# ROAD SAFETY AUDIT

EXISTING CONDITIONS ROAD SAFETY AUDIT

INKERMAN ROAD, ST KILDA EAST

CLIENT: City of Port Phillip

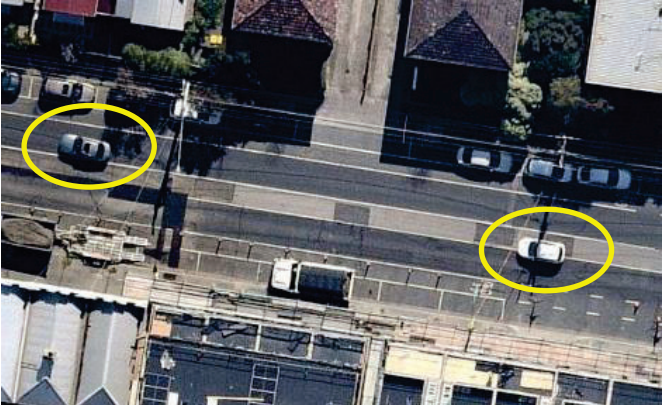
| No. | Audit Findings                                                                                                                                                                                                                                                                                                                                                                                                                                                                                                                                 | Frequency /<br>Severity / Risk            | Audit Recommendations<br>P – Primary S – Supporting<br>O – Other Treatment                                                                                                  | PROJECT MANAGER RESPONSE     |                                                                                                                                                                                       |
|-----|------------------------------------------------------------------------------------------------------------------------------------------------------------------------------------------------------------------------------------------------------------------------------------------------------------------------------------------------------------------------------------------------------------------------------------------------------------------------------------------------------------------------------------------------|-------------------------------------------|-----------------------------------------------------------------------------------------------------------------------------------------------------------------------------|------------------------------|---------------------------------------------------------------------------------------------------------------------------------------------------------------------------------------|
|     | At the mid-block crossing point east of Henryville Street, directional TGSIs should be provided to give directional orientation to vision impaired pedestrians to access the crossing point.<br><br><i>Safe System Tolerance: N/a</i>                                                                                                                                                                                                                                                                                                          |                                           |                                                                                                                                                                             |                              |                                                                                                                                                                                       |
